# UNITED STATES PATENT AND TRADEMARK OFFICE

10/810,452

# Office Action Summary

**DETAILED ACTION*****Claim Rejections - 35 USC § 103***

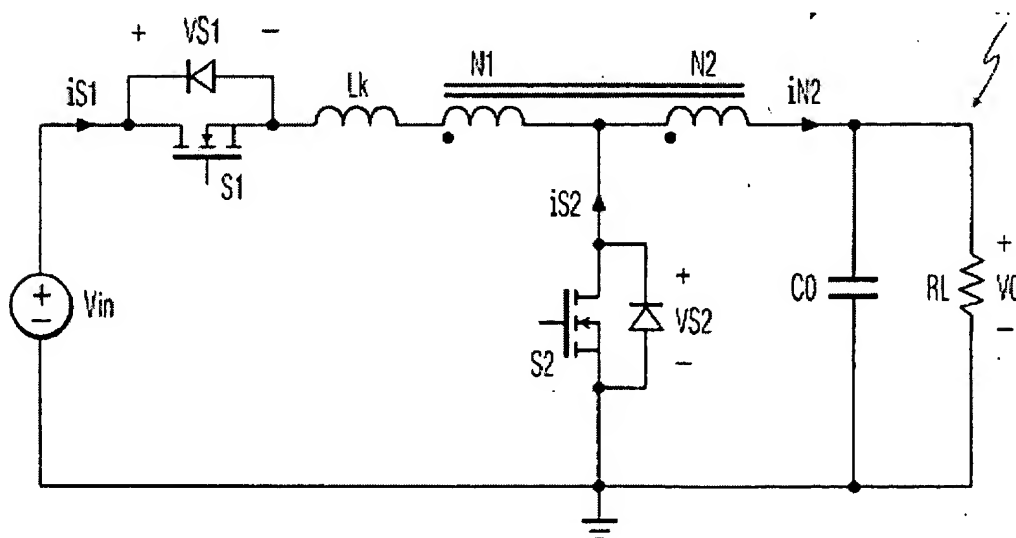
2. Claims 1, 4, 5, 6, 9, 11, 14, 15, 16, 19, 21 and 23 rejected under 35

U.S.C. 103(a) as being unpatentable over Qian (USP 6,512,352) in view of Lu et al.

(USP 5,636,107). Qian discloses the claimed invention a coupled inductor with first, N1, and second, N2, windings connected in series to form a common node, a conduction switch, S1, and a freewheeling switch, S2, the inductor is formed on a single core, and an output capacitor, Co. See figure below.

Qian discloses the claimed invention except for turns ratios of the inductor devices. Lu discloses that it is known in the art to provide the turns ratios of the inductor devices of having a relationship of the  $N1/N2$  windings of the transformer to be 2. The turns ratio indicates the amount by which the transformer increases or decreases the voltage applied to the primary. For example, if the secondary of a transformer has two times as many turns as the primary, the voltage induced into the secondary will be two times the voltage across the primary. (As is with the case of applicant's claimed invention). If the secondary has one-half as many turns as the primary, the voltage across the secondary will be one-half the voltage across the primary. However, the turns ratio and the current ratio of a transformer have an inverse relationship. Thus, a 1:2 step-up transformer will have one-half the current in the secondary as in the primary. A 2:1 step-down transformer will have twice the current in the secondary as in the primary. (As is with the case of applicant's claimed invention).

It would have been obvious to one having ordinary skill in the art at the time of the invention was made to provide the turns ratios of the inductor devices of having a relationship of the  $N1/N2$  windings of the transformer to be 2 of Lu with the controlled inductive switching circuit of Qian, in order to provide a simplistic approach to control the output voltage and output current induced in the secondary by changing the turns ratio of the transformer.
